**MINUTES  
BOARD OF BUILDING STANDARDS/  
ARCHITECTURAL BOARD OF REVIEW/SIGN REVIEW  
REVIEW MEETING  
CITY OF LAKEWOOD  
12650 DETROIT AVENUE  
AUDITORIUM  
AUGUST 11, 2022  
5:30 P.M.**

**ARCHITECTURAL BOARD OF REVIEW**

**Docket No. 08-49-22 (1491 Spring Garden)**

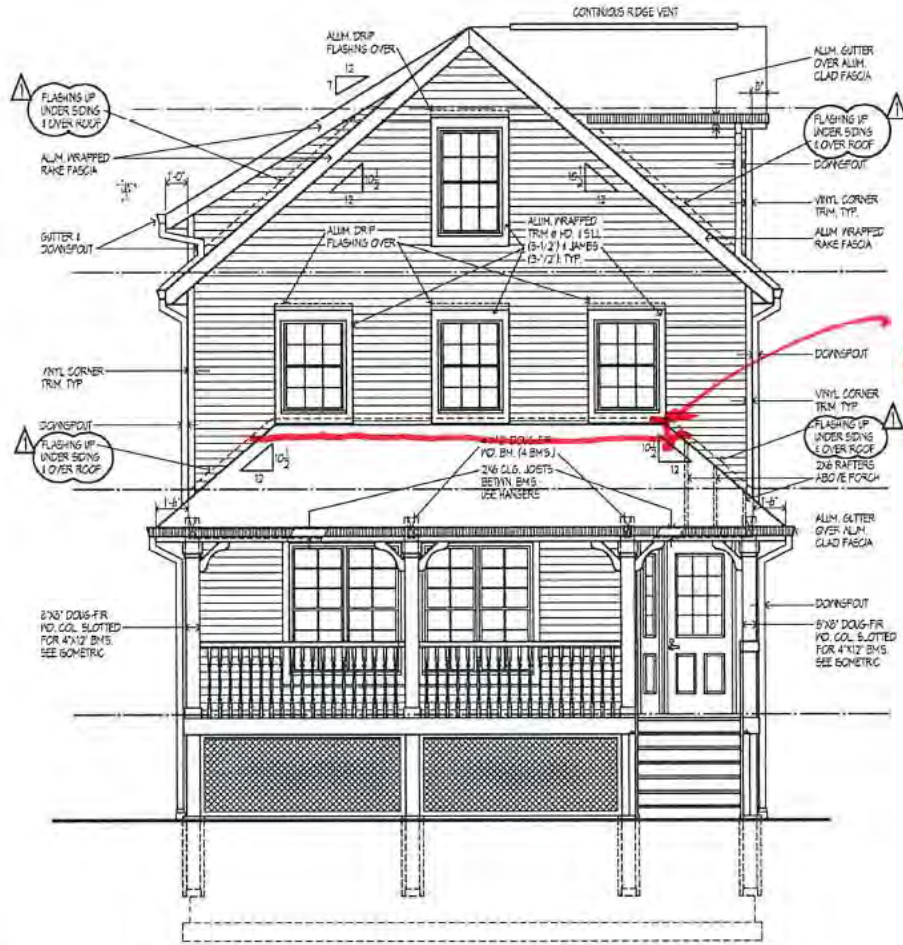
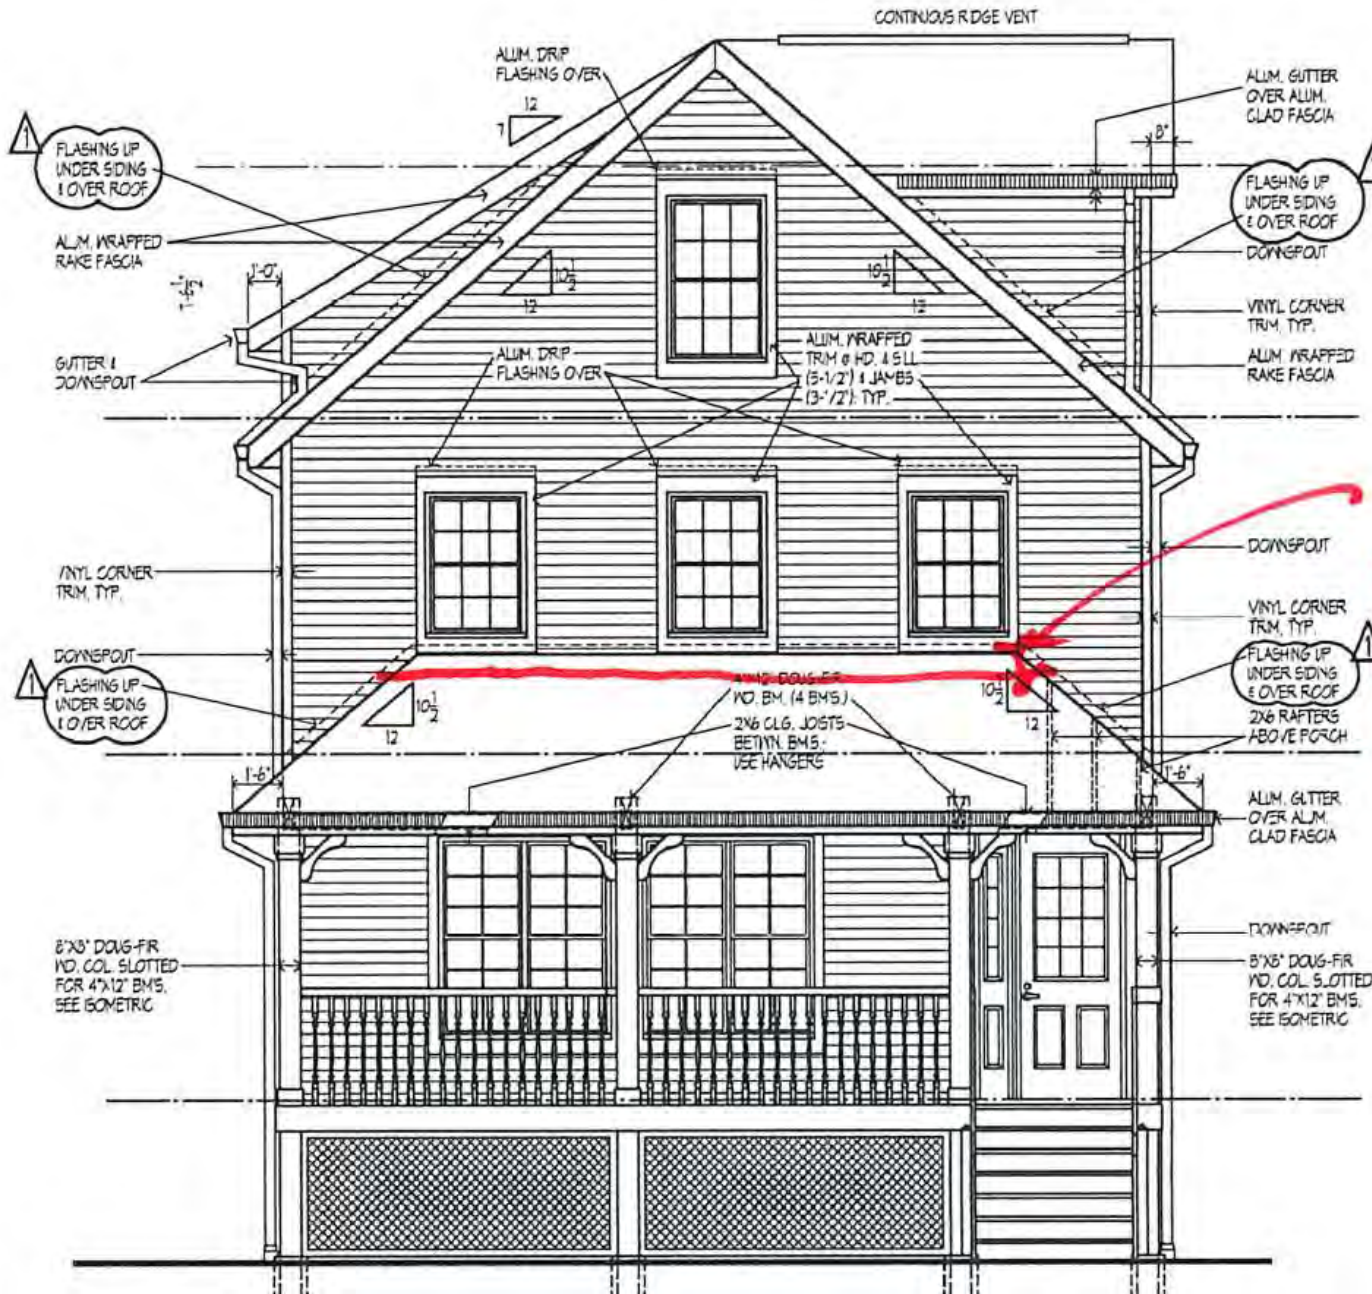
- Materials used on new home do not match what was proposed/approved (Aug 2020).

**DROP GIG. ROOF AT LEAST 8" BELOW WINDOWS.**

**ENCLOSE W/ LATTICE**

A motion was made by Mr. Maniet, seconded by Mr. Donaldson to **DENY** the request for modifications. All the members voting yea, the motion passed.

**Docket No. 08-50-22 (14429 Delaware)**

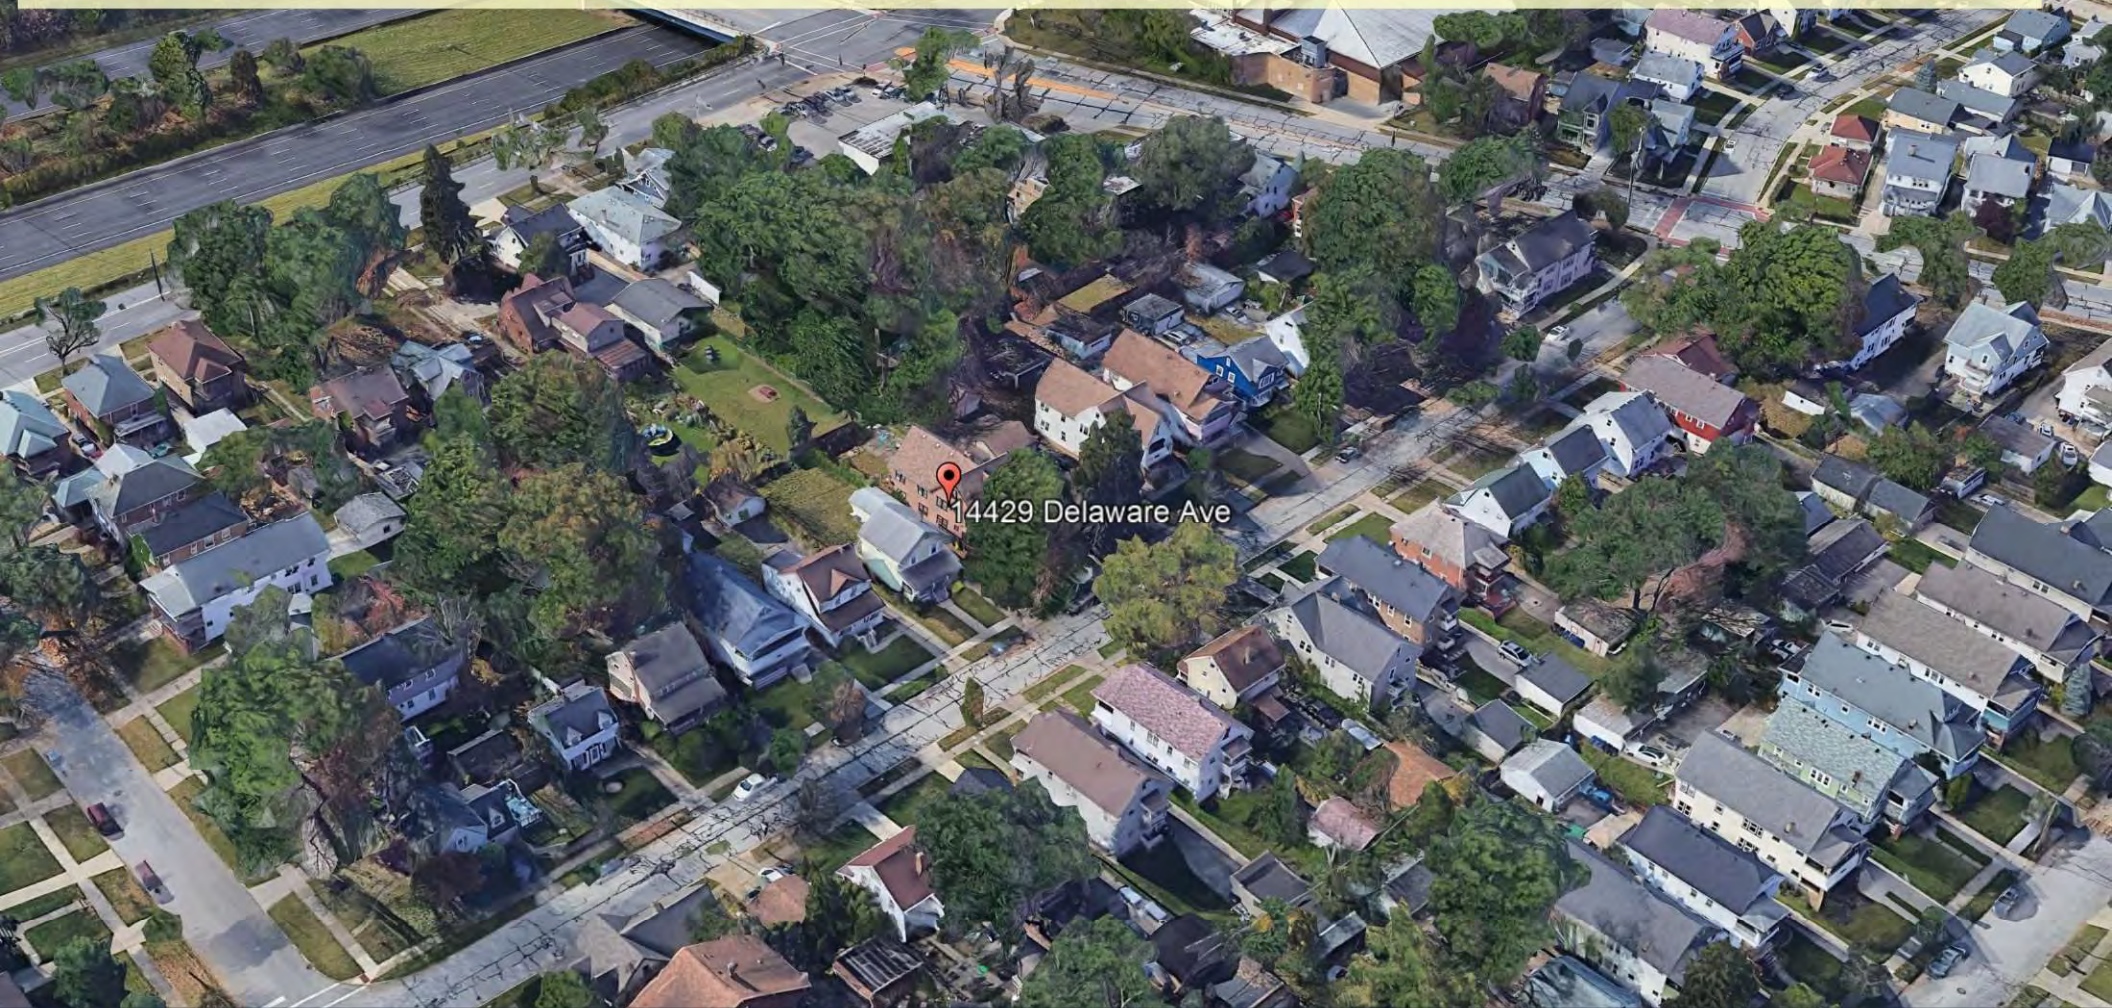
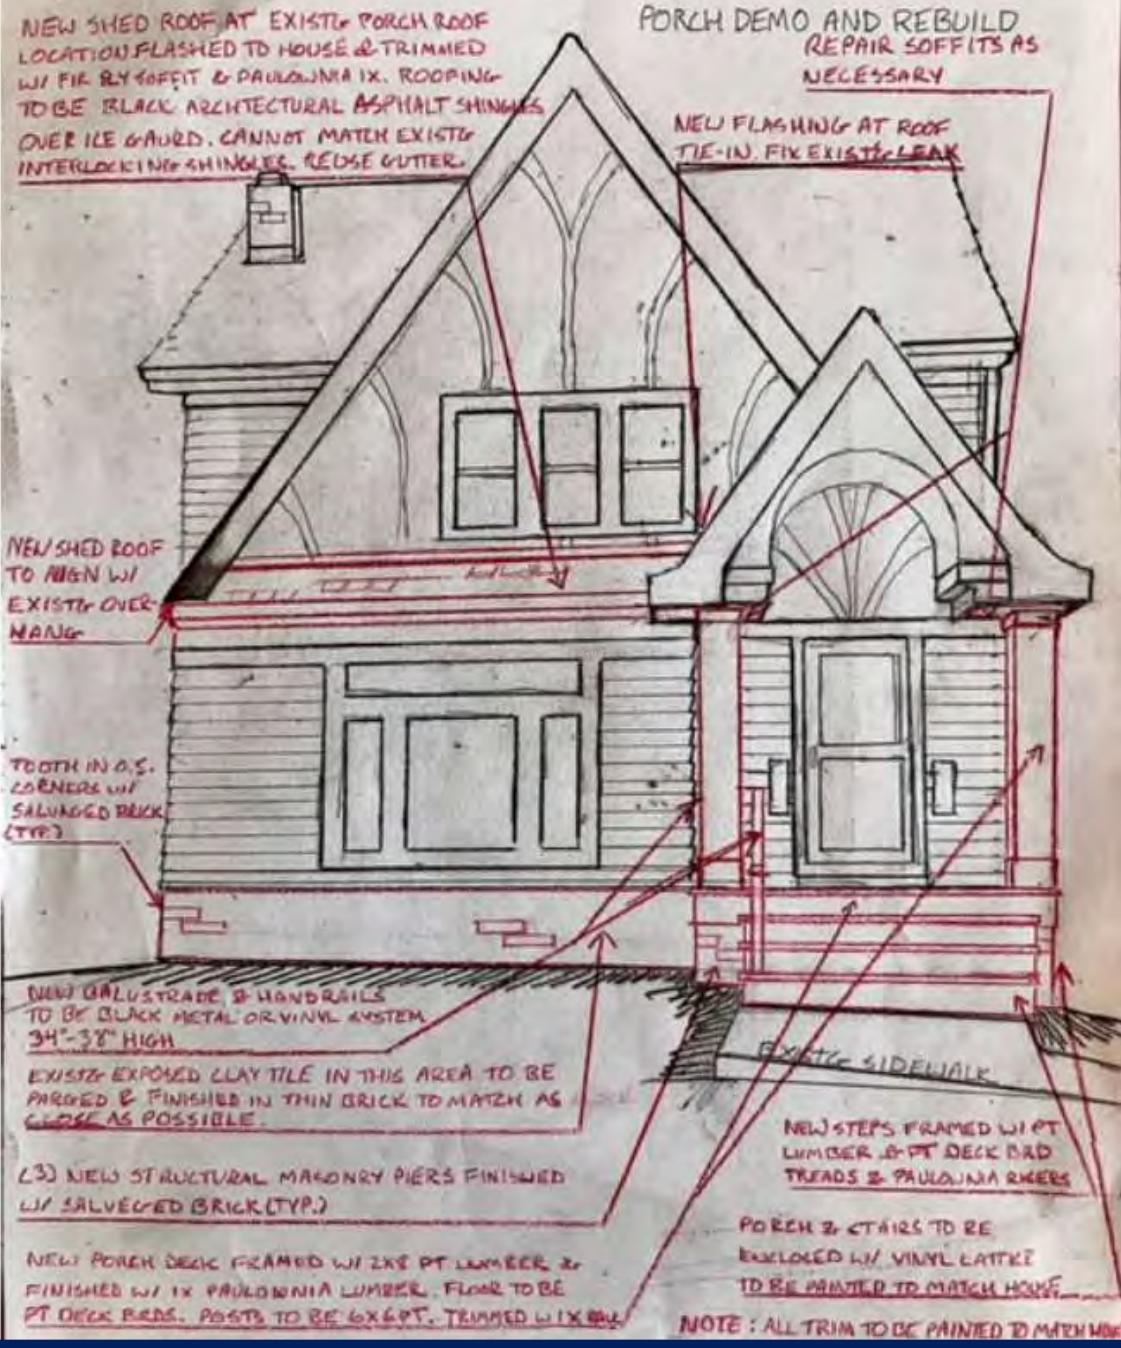
Nate Birch, Birch Construction, representative was present to explain the request. The members were sorry for the removal of the large porch, said the proposal was a good compromise, asked about shingle samples, discussed the columns (dimensions and color), the railings, shed roof overhang. Staff liked the design and said that the shingles to match the existing would not be found. Public comment was closed as no one addressed the item. Staff do not receive any communication.

- Request details on extent/integration of new shed roof element with remaining portion of the front porch.
- Provide manufacturers cut sheets or photo examples of any new finish materials.
